PROPOSED KLONDYKE WATER STORAGE ASSESSMENT OF NOISE EFFECTS

Report No 15092v2

Marshal Day Review

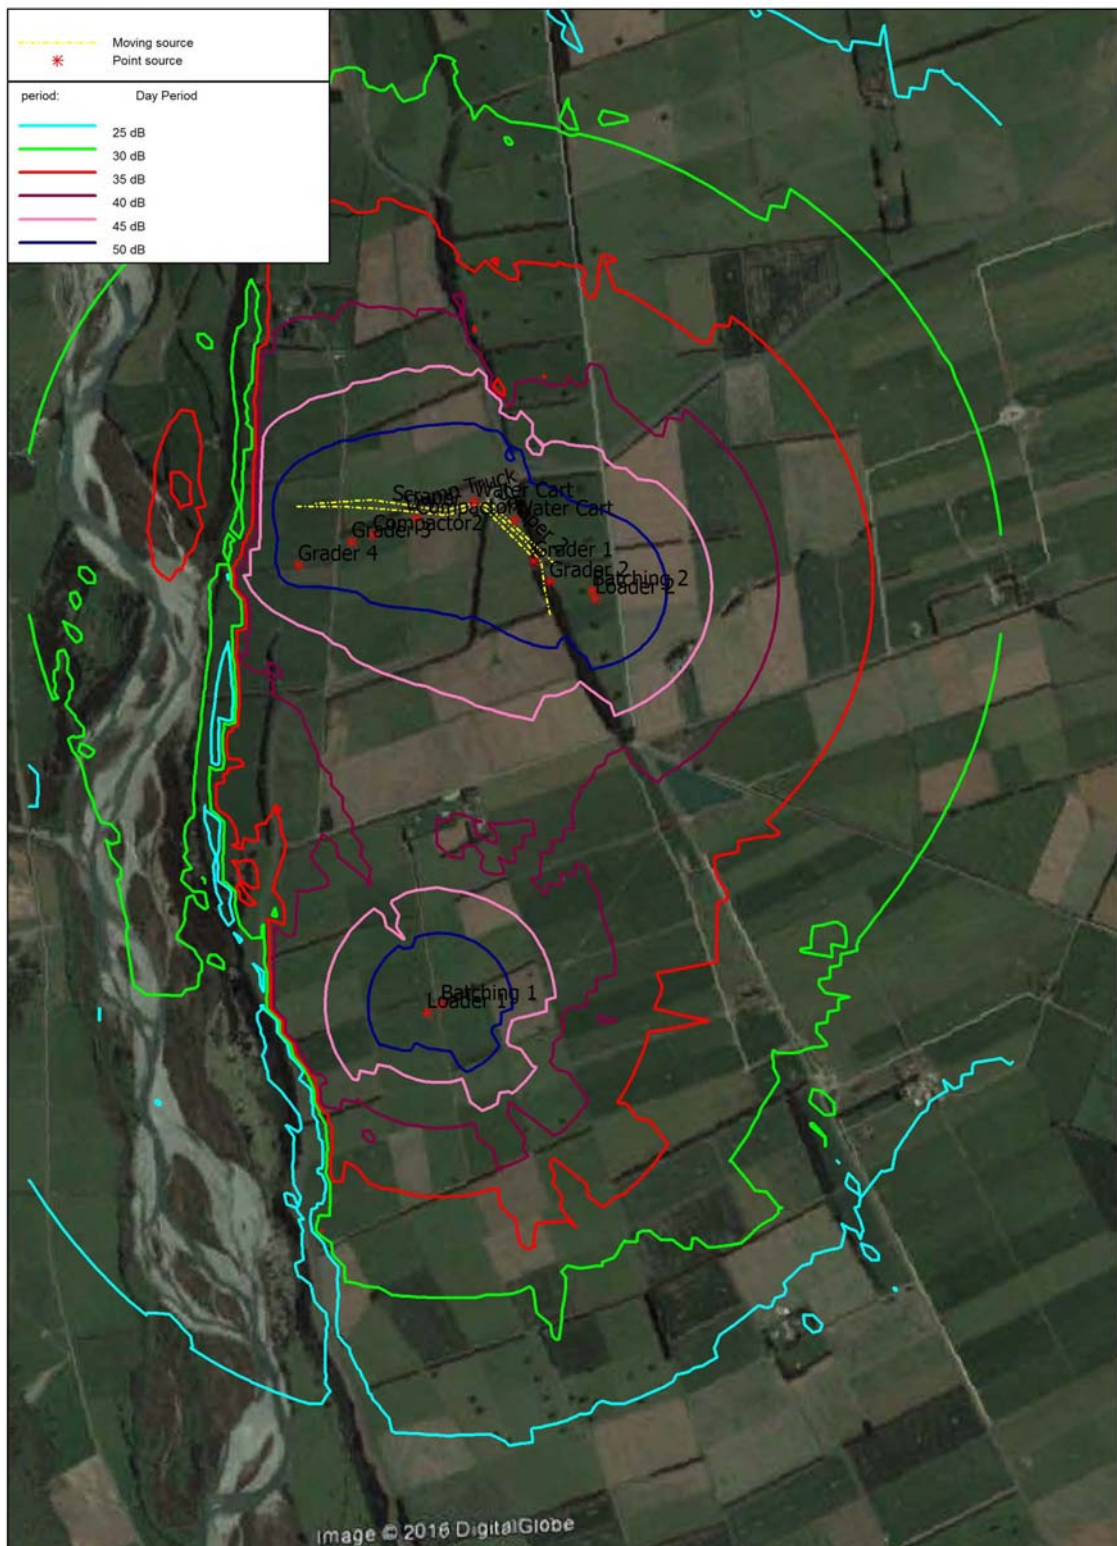
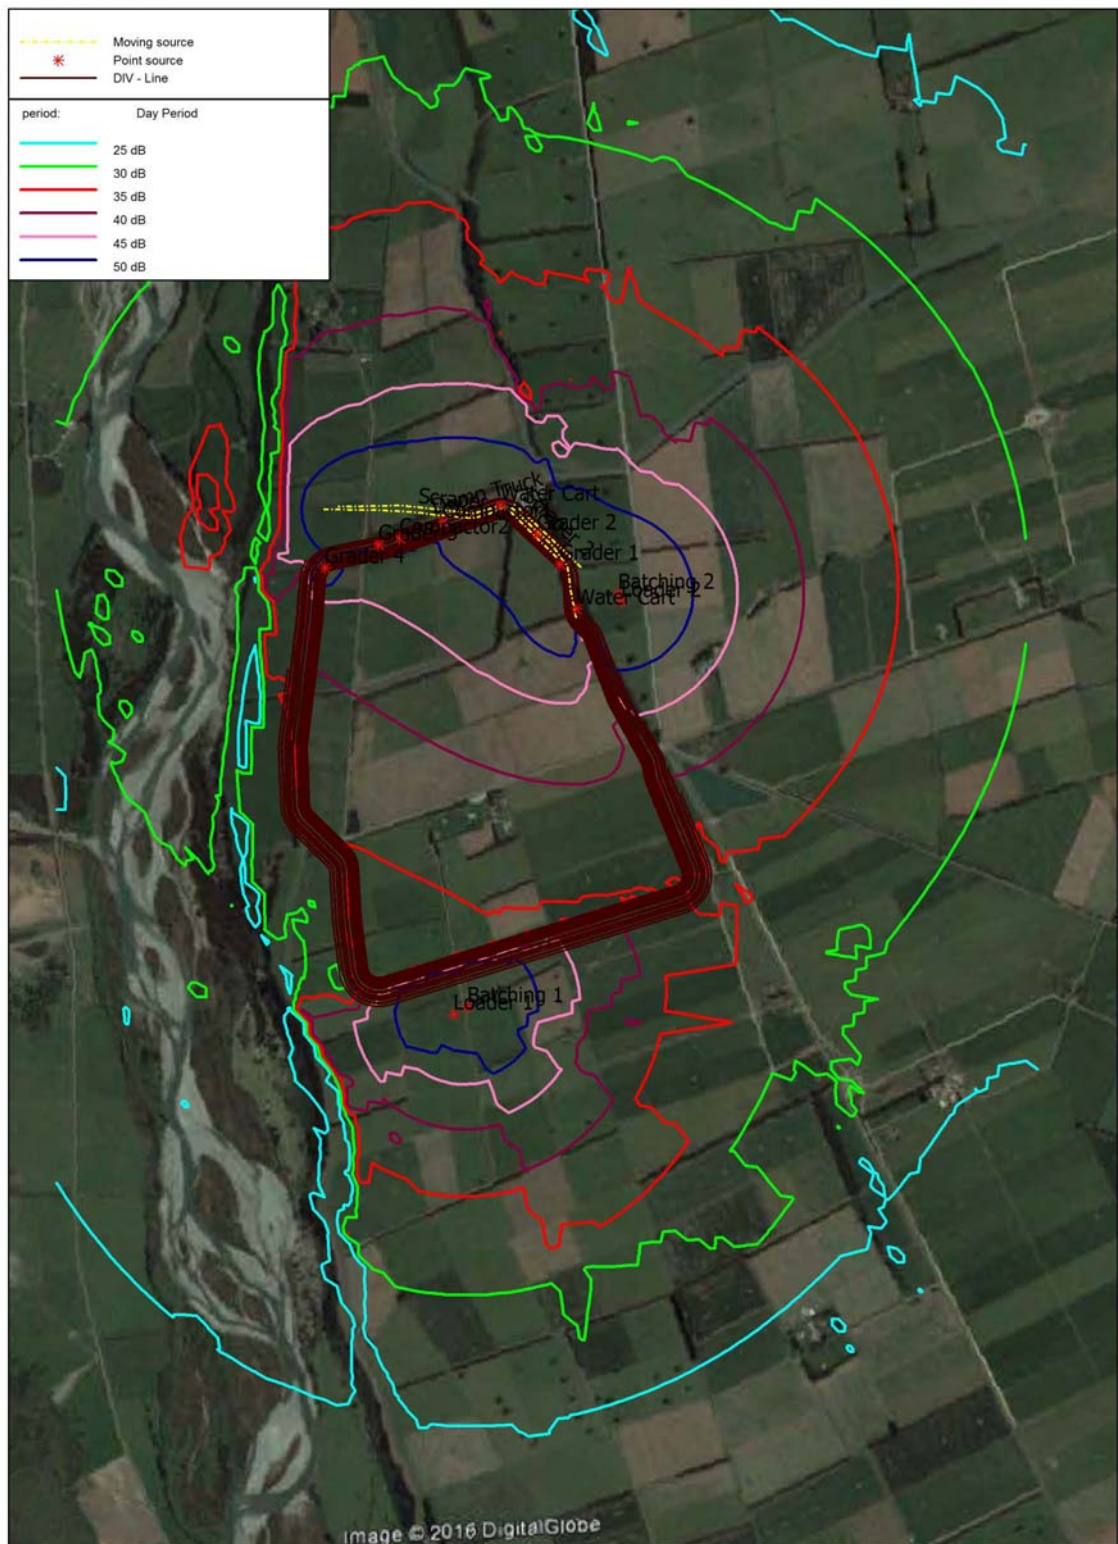
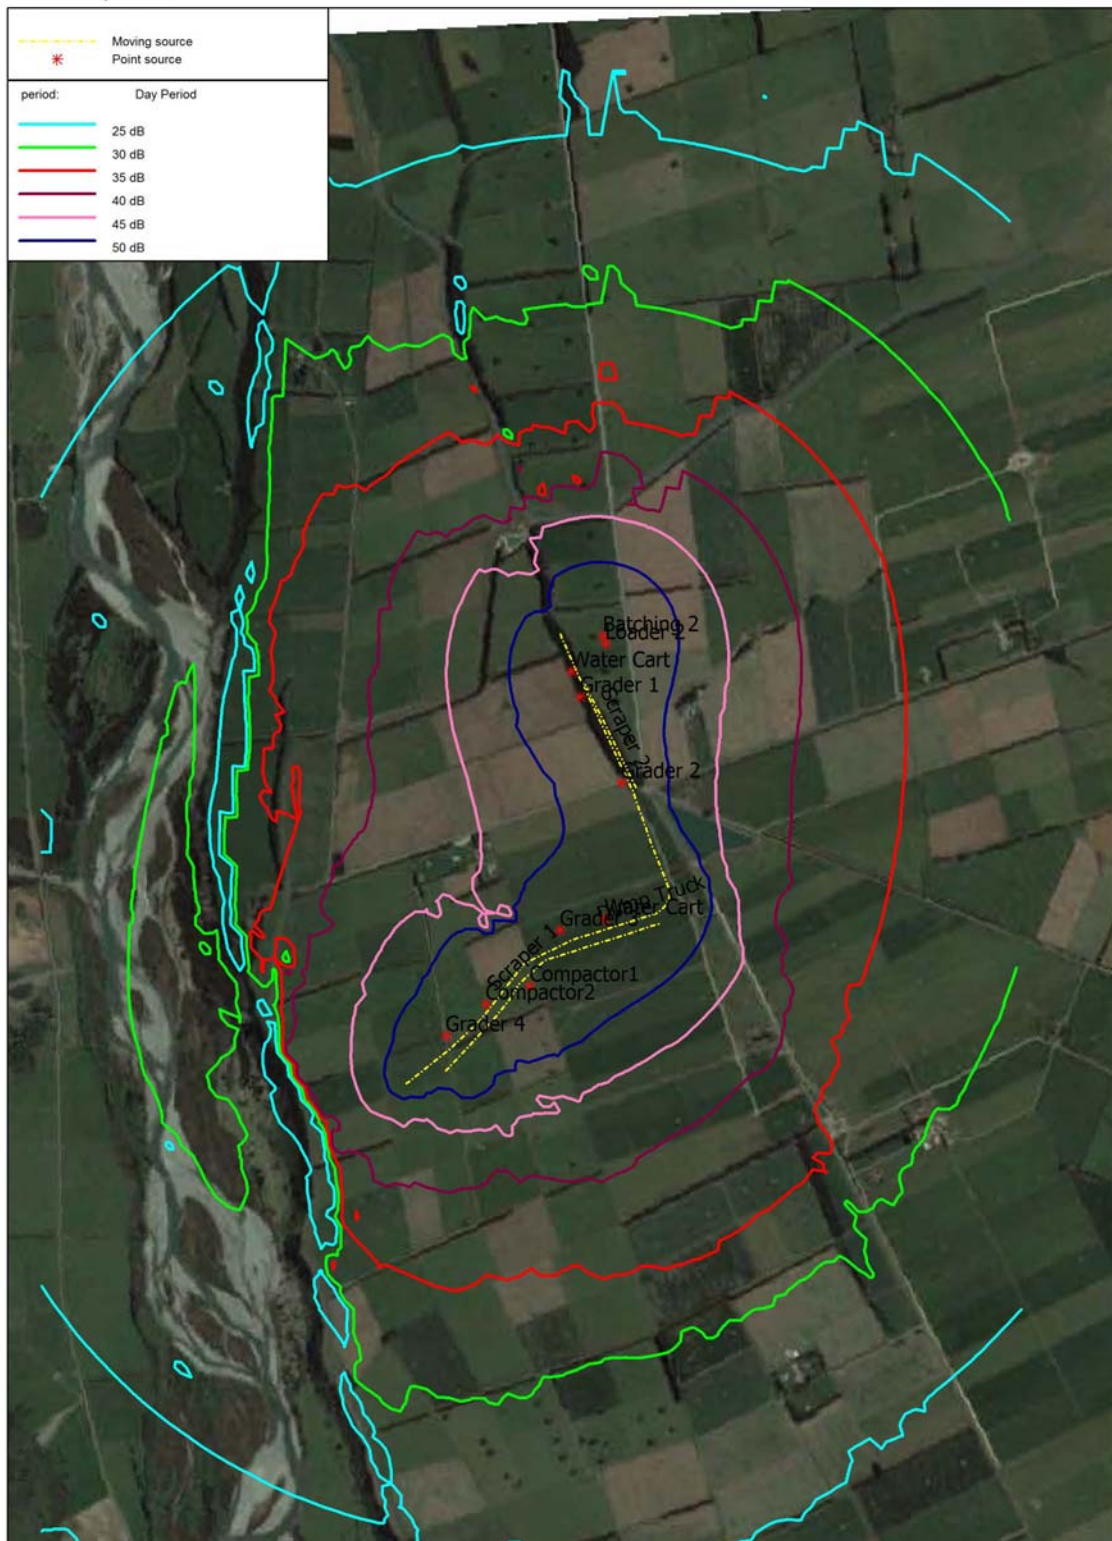
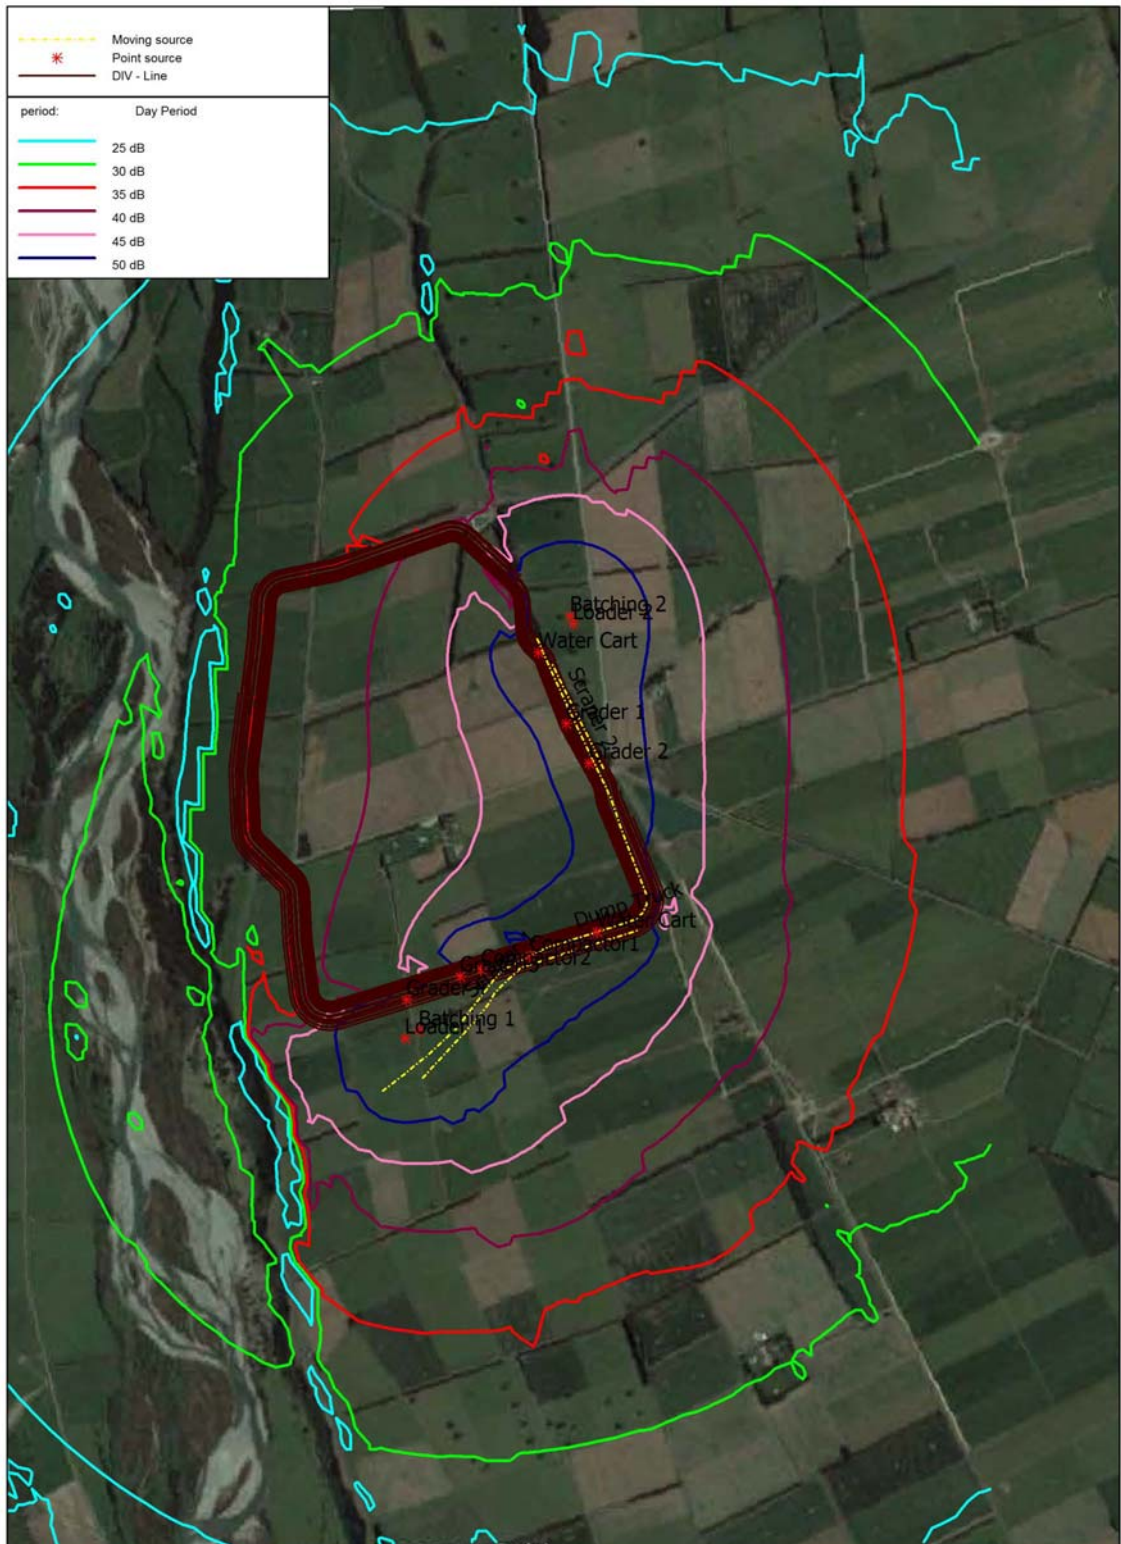
As the Report is a draft, it may be beneficial to address some general formatting matters ahead of the final version to ease interpretation. In particular: noise contour plots could usefully show dwellings; moving source paths could be more clearly denoted on these plots; and the dwellings in Figure 11 could be numbered in accordance with the sites in Table 2.

The figures have been modified to show the moving sources in yellow.

Figure 10. Location of Spot Noise Predictions

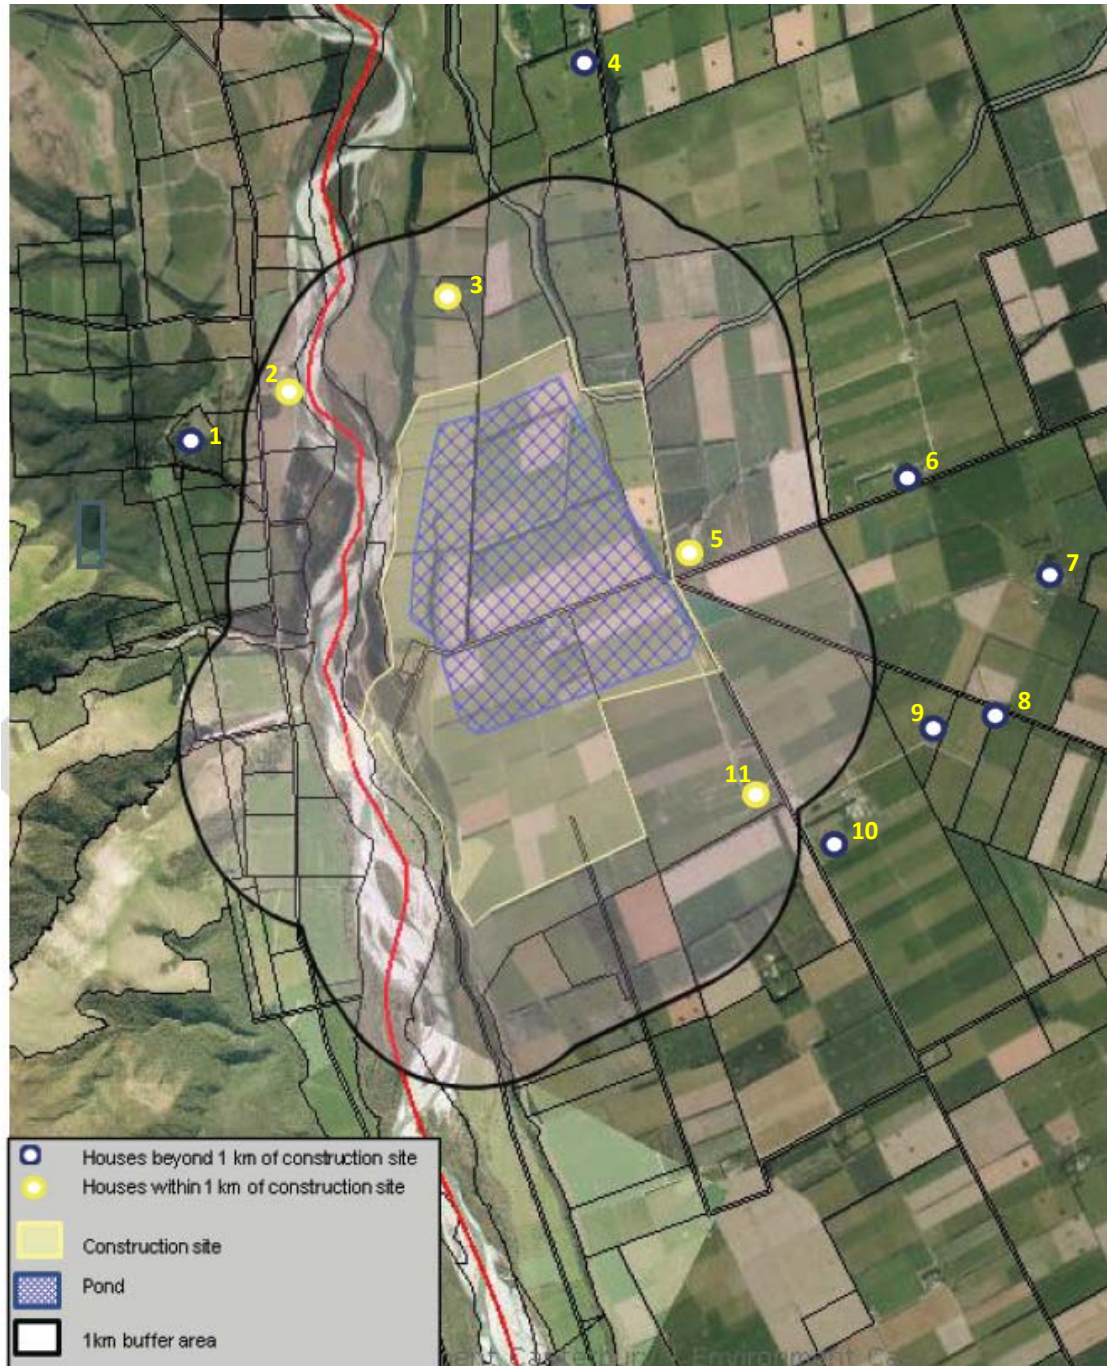
Dwellings at locations 1 and 2 in Figure 10 are within the Timaru District. The Report does not discuss operational noise received here in the context of noise standards in the Timaru District Plan, nor establish any differences in the assessment of construction noise compared to the Ashburton District.

The Ashburton District Plan is the relevant control but a discussion of the Timaru District Plan has been included in the noise assessment. It is noted the noise requirements of both District Plans are similar.

Figure 11. Bridge 3

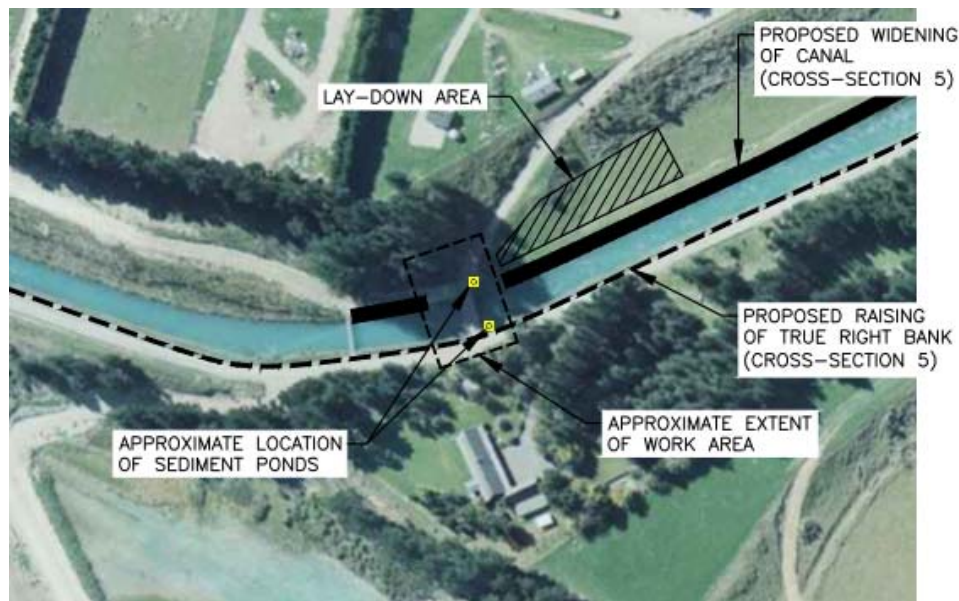
We have a number of concerns around the dwellings shown in Figure 11 (adjacent to "Bridge 3"):

- a) Piling will occur close to these dwellings, yet the methodology is not discussed in detail.*
- b) The Report generally asserts that "by complying with the L_{Aeq} levels the L_{Amax} will also be complied with", yet no information or assessment is provided. Whilst we generally agree for typical construction noise sources, this may not be the case for the piling, depending on the method used.*

- c) Similarly, in the Conclusions section, the discussion of vibration effects is introduced. Again, this is likely not a significant issue for general construction activities, but some piling methods may cause high vibration levels in this area.*

- d) Some infrequent night-time activity (e.g. concrete pours) is mentioned in the Report. The low night-time noise limits could mean that this activity does not comply at this time. This is particularly so for dwellings close to Bridge 3 if night-time pours are anticipated at this site.*

Figure 11 relates construction noise at Bridge 3, more than 5km north of the proposed construction work on the water storage area. Table 2 relates to work undertaken on the preparation of the water storage area so the two areas are sufficiently far apart that it is considered they should be reported separately as they relate to a different group of residents. However, the noise effects are reported in the same section of the report so easily identified by the affected residents.

The report has been updated to include piling at Bridge 3.

Field measurements have shown that for the proposed construction work (including the type of piling proposed) if the L_{Aeq} is complied with the L_{Amax} will also be complied with. This is the advantage of using L_{Aeq} rather than L_{10} (as adopted in NZS6803P:1984) as the short duration effects of L_{Amax} are included in the L_{Aeq} measurement.

Vibration effects have been monitored at an existing site close to the type of piling proposed and shown to comply with the requirement of Standard DIN 4150-3 (1999): Structural Vibration – Part 3 Effects of Vibration on Structures with a good factor of safety. The distance to the closest dwelling in this case is more than three times greater than monitored in the above case. No vibration issues are expected for any of the proposed construction works.

No contract for the work has been let at this stage so the likelihood of any night time work is an unknown. In the event there is night time work proposed this will be dealt via a noise management plan. This will include implementing noise control techniques, adopting the best practicable option (as set out in NZS6803), working with neighbours, timing of the work and any other options that may be available when the issues are known.
